GAJA HITECH AGRO, GJ-C3000, CHAFF CUTTER

NORTH EASTERN REGION FARM MACHINERY TRAINING & TESTING INSTITUTE

Machine 154/528	GAJA HITECH AGRO, GJ-C3000 CHAFF CUTTER	COMMERCIAL (INITIAL)
-----------------	--	-------------------------

Fig.1. GAJA HITECH AGRO, GJ-C3000, CHAFF CUTTER

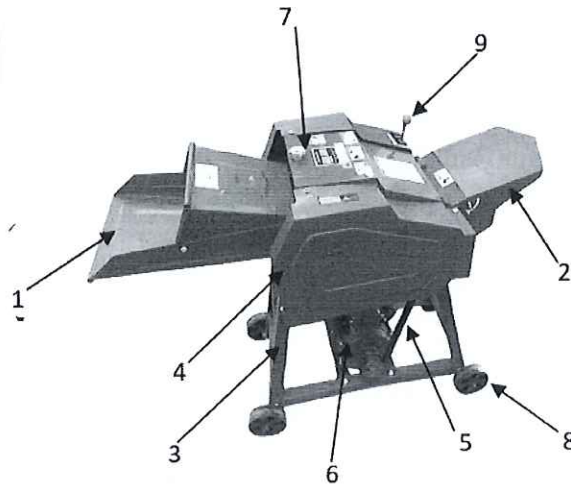
- 11.1.1 A warning roller with spring was not fitted before the feeding rollers to warn the operator while feeding the fodder crop into the chaff cutter. This should be looked into for corrective action.

- 11.1.2 A suitable arrangement was not provided for clutching or declutching of drive in transmission system. This should be looked into for corrective action.

- 11.1.3 The power source shall be mounted on a frame made of MS angle with minimum thickness of 5 mm. This should be looked into for corrective action.

- 11.1.4 Pulley diameter of power source shall be of 100 mm. This should be looked into for corrective action.
- 11.1.5 Diameter of cylinder pulley shall be minimum 265 mm. This should be looked into for corrective action.

- 11.1.6 The minimum length of chute shall be 900 mm. This should be looked into for corrective action.
- 11.1.7 The chute shall be covered up to a minimum of 450 mm near feed roll side. This should be looked into for corrective action.

- 11.1.8 Provision to change the direction of rotation of feed rolls should be provided.
- 11.1.9 Hooks at suitable places may be provided for lifting the chaff cutter for easy movement.

- 11.1.10 The thickness of the chute cover shall not be less than 1.6 mm
- 11.1.11 The height of feeding chute of chaff cutter should be between 750 to 1100 mm

- 11.1.12 The chemical composition and hardness of blade is not meeting the requirement of IS 11459 : 2024. This should be looked into for corrective action.

We will do the corrective action on your comments and recommendation.
